HISTORIC AND DESIGN REVIEW COMMISSION

HDRC CASE NO: 2017-588
ADDRESS: 814 BURNET ST
LEGAL DESCRIPTION: NCB 549 (814 BURNET SUB'D {IDZ}), BLOCK 9 LOT 18
ZONING: IDZ, H
CITY COUNCIL DIST.: 2
DISTRICT: Dignowity Hill Historic District
APPLICANT: Felix Ziga/Ziga Architecture Studio
OWNER: Poma Properties, LLC
TYPE OF WORK: Construction of four, two story, single family residential structures
APPLICATION RECEIVED: November 8, 2017
60-DAY REVIEW: January 7, 2018
REQUEST:

The applicant is requesting conceptual approval to construct four, two story residential structures on the vacant lot at 814 Burnet.

schematic design: proposed site / roof plan

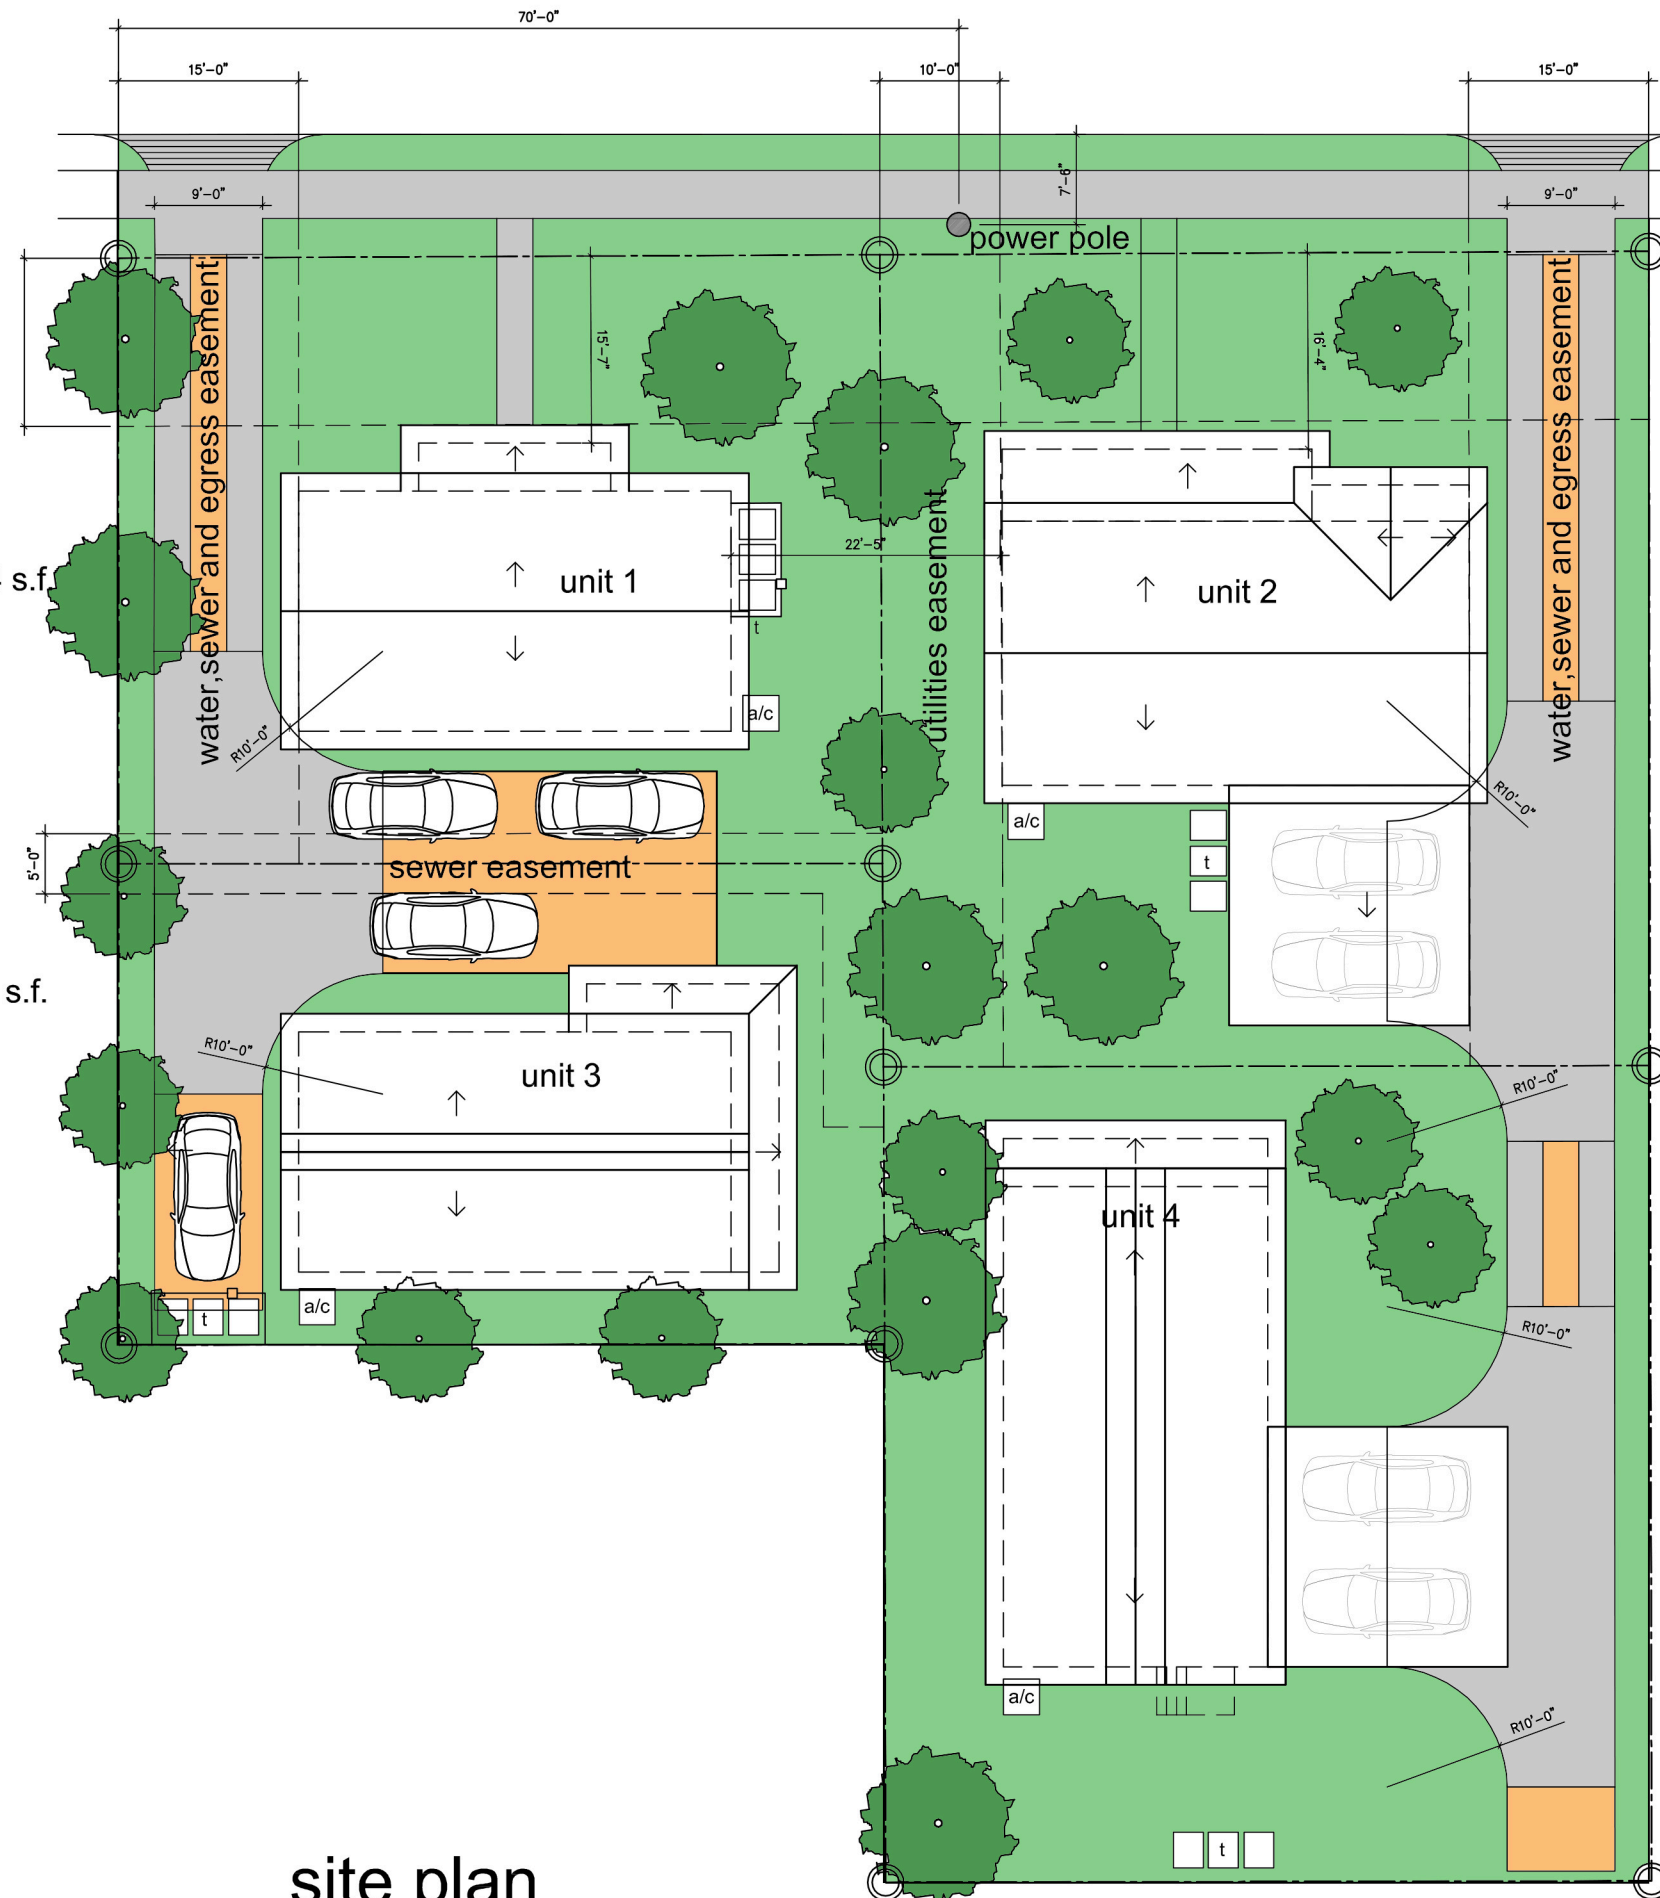
- q. **SIDEWALK** – The applicant has noted the installation of a front yard sidewalk for units 1 and 2; however, has not included these on the site plan. The proposed sidewalks should relate to those found historically in the district in terms of location, width and material and should be centered on the front porch of units 1 and 2.

- t. **LANDSCAPING** – The applicant has noted the location of trees and driveways on the site plan; however, a detailed landscaping plan should be submitted to staff prior to submitting for final approval.

- v. That all concrete sidewalks found on site be consistent with those found historically in the district.
- vi. That a detailed landscaping plan be submitted prior to submitting for final approval.

schematic design: proposed elevations - unit 1

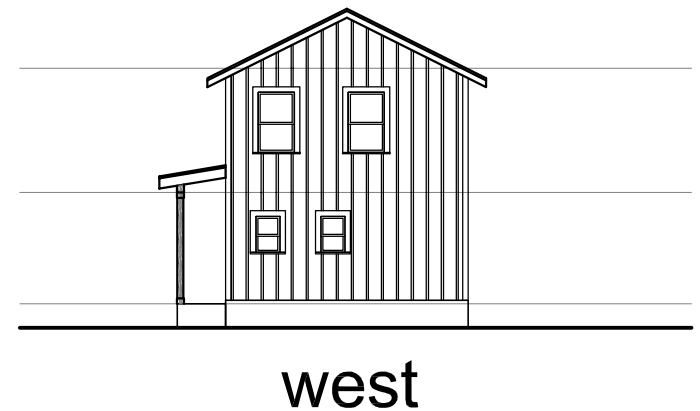
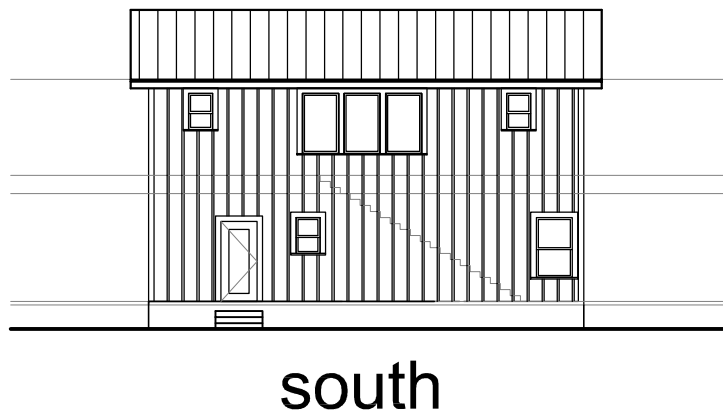
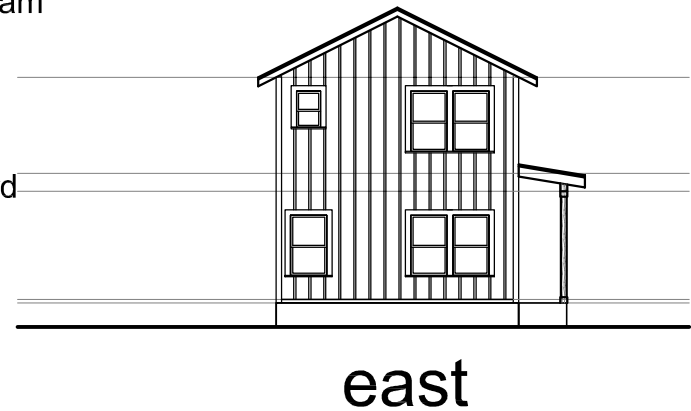
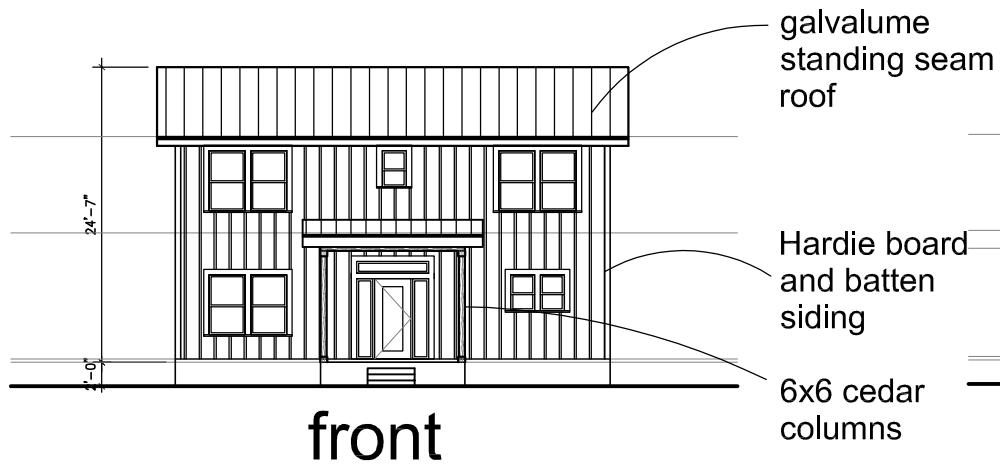
- k. **WINDOW & DOOR OPENINGS** – Per the Guidelines for New Construction 2.C.i. window and door openings with similar proportions of wall to window space as typical with nearby historic facades should be incorporated into new construction. Staff finds that window locations and groupings should be revised to include proportionate locations such as distances from building corners and proportionate mullion spacing between grouped windows.

- n. **ARCHITECTURAL DETAILS** – The applicant has proposed for each structure to have covered porches which are currently designed as stoops with shed roofs. Staff recommends the applicant incorporate additional porch massing and work to include the design of the porches into the overall building’s mass.

- vii. That window locations and groupings should be revised to include proportionate locations such as distances from building corners and proportionate mullion spacing between grouped windows.

Staff recommends conceptual approval of units 1, 3 and 4 based on findings d through t with the following stipulations:

schematic design: proposed elevations - unit 2

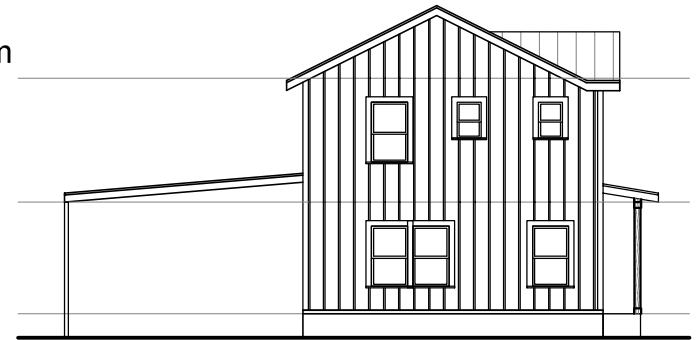
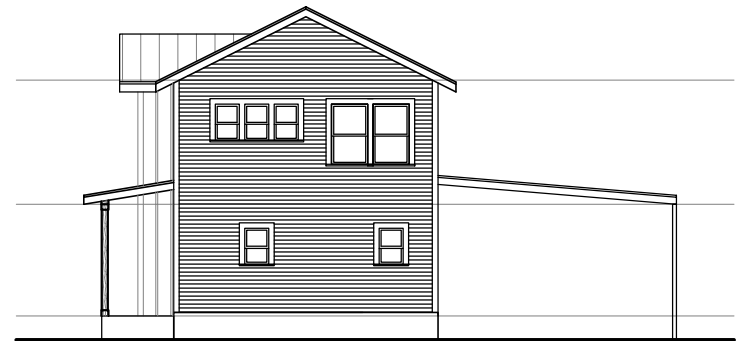
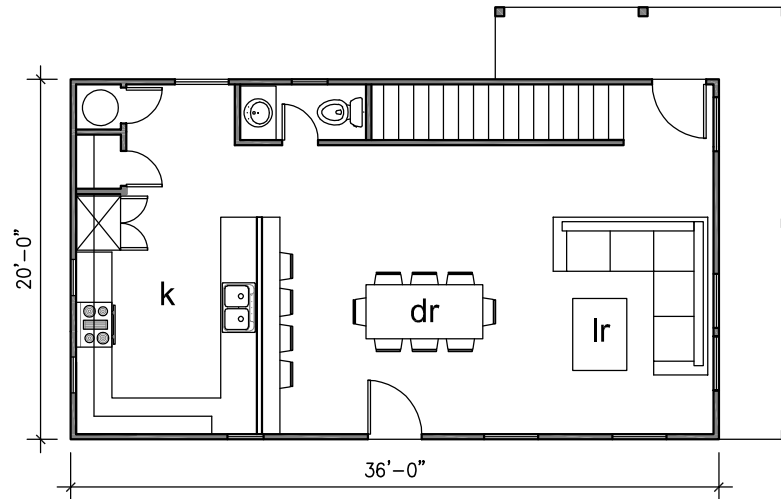
- o. **ARCHITECTURAL DETAILS** – Folk Victorian structures rely heavily on the relationship between front protruding window bays, side gables and inset porches. The front facing gable should extend to the top of the cross ridge line to present equal heights for both portions of the L plan. This has not been accomplished in unit 1. Additionally, porches on Folk Victorian structures are recessed behind the massing of protruding bays. As proposed, the applicant has proposed a porch that extends forward from the massing of the new construction. This is not architecturally appropriate.

Staff does not recommend approval of unit #2. Staff recommends That additional architectural detailing be added that is consistent with Folk Victorian detailing including window proportions that feature additional height, transom windows above each entrance, equal spacing between windows, and consistent relationships between solids and voids. The proposed short windows in bathrooms on the front façade should be eliminated and full height windows should be installed. The front facing gable should extend to the top of the cross ridge line to present equal heights for both portions of the L plan. Additionally, a true L plan should be designed which includes a protruding bay and recessed porch massing.

GENERALLY APPROPRIATE. ADDRESS SQUARE WINDOWS. ADD ADDITIONAL

SCALED REFERENCES TO PRESENTATION. ED: CONSIDER ELONGATED

ELEMENTS -> RECTANGULAR WINDOWS, TRANSOM ABOVE DOOR,
